# STATE OF VERMONT AGENCY OF TRANSPORTATION

## PROPOSED IMPROVEMENT BRIDGE PROJECT TOWN OF PLYMOUTH COUNTY OF WINDSOR VT 100A (MAJOR COLLECTOR) BRIDGE NO.8

| RECORD PLANS                                                                                                                                                           |                                          |

DIRECTOR OF PROGRAM DEVELOPMENT  
APPROVED Richard J. Fournier DATE 7/20/12  
PROJECT MANAGER : ROB YOUNG  
PROJECT NAME : PLYMOUTH  
PROJECT NUMBER : ER BRS 0149 (5)  
SHEET 1 OF 46 SHEETS

| W.W. FORMING PLAN        | SHEET NUMBER                 |

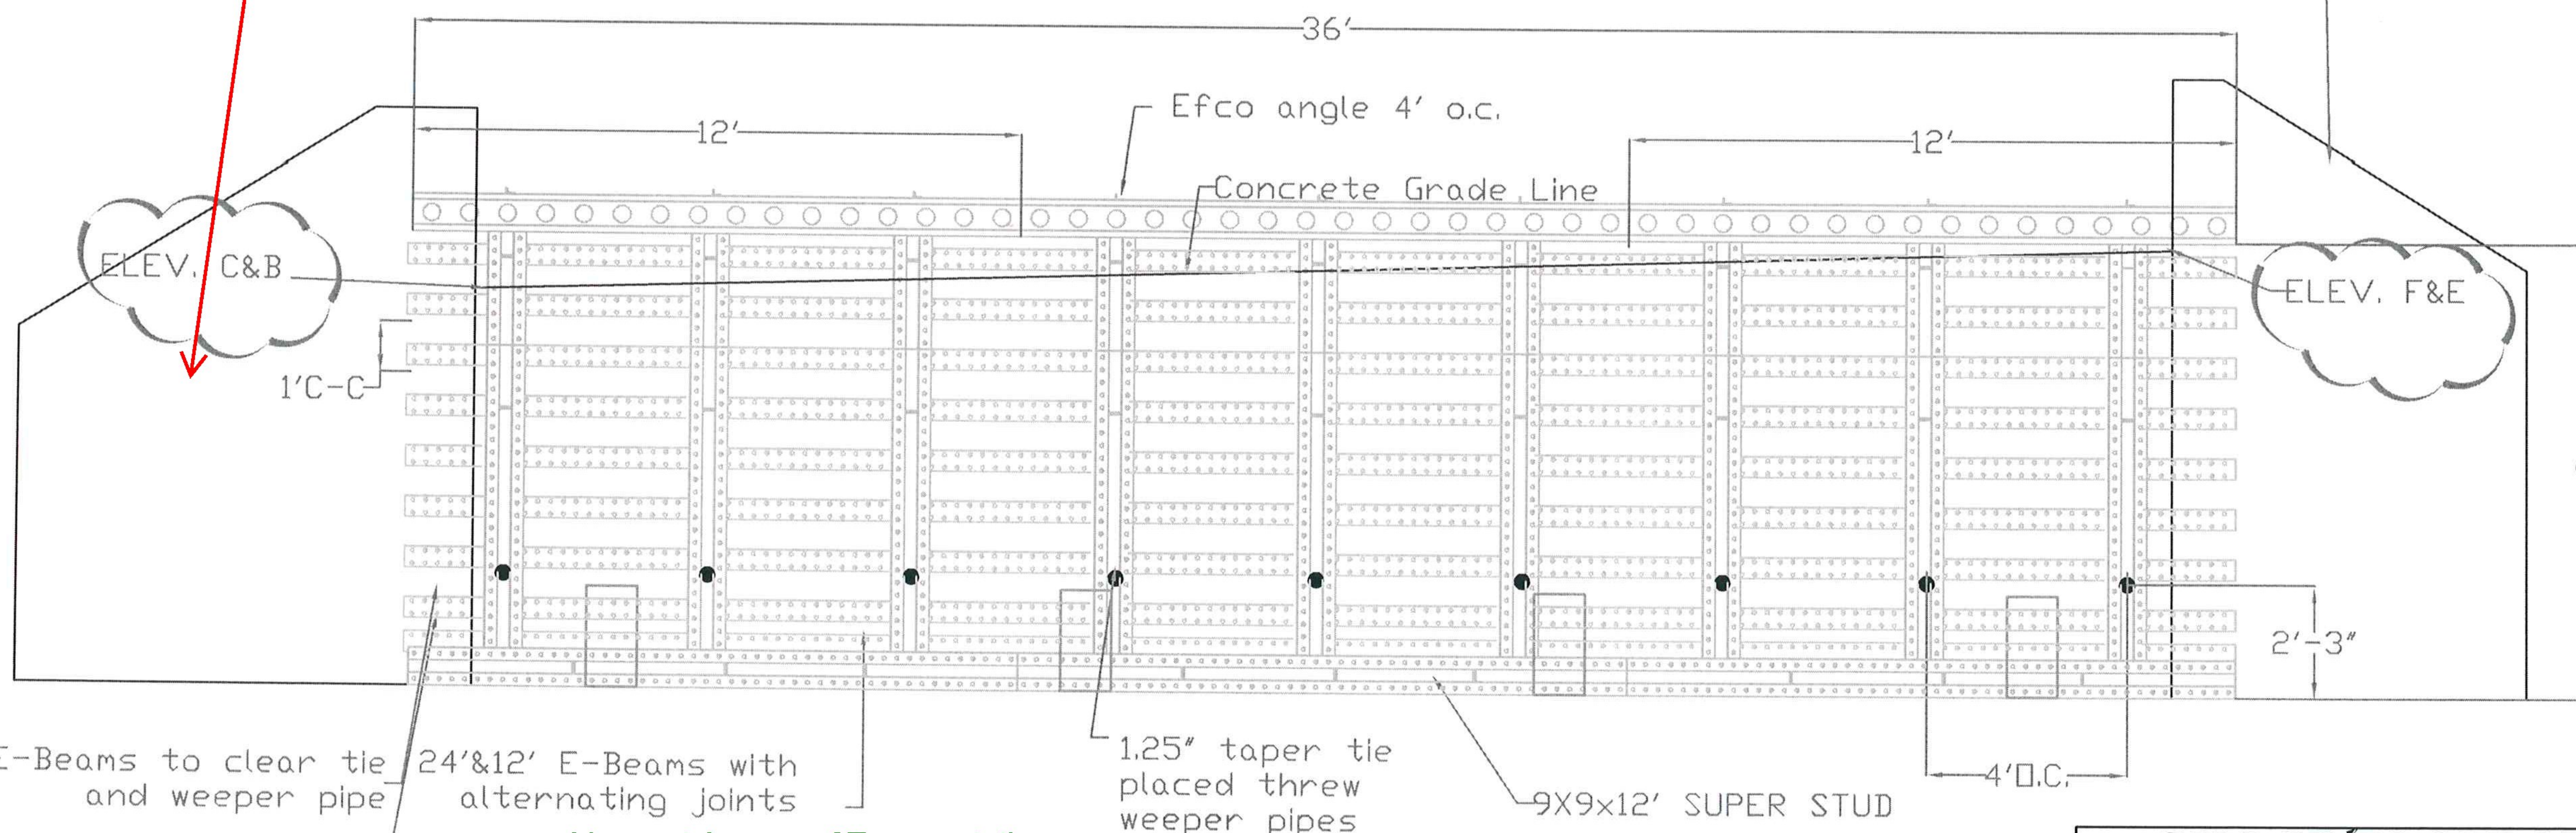
ABUTMENT #1  
 ELEVATION "C" ~~1046.92~~ 1046.12 (NF), 1046.24 (FF)  
 ELEVATION "F" ~~1045.26~~ 1045.13 (NF), 1045.26 (FF)  
 ABUTMENT #2  
 ELEVATION "B" ~~1043.68~~ 1043.80 (NF), 1043.68 (FF)  
 ELEVATION "E" ~~1044.67~~ 1044.79 (NF), 1044.67 (FF)

Need to laterally brace wings to prevent 'tipping' during abutment closure cure period

Space E-Beams to clear tie and weeper pipe
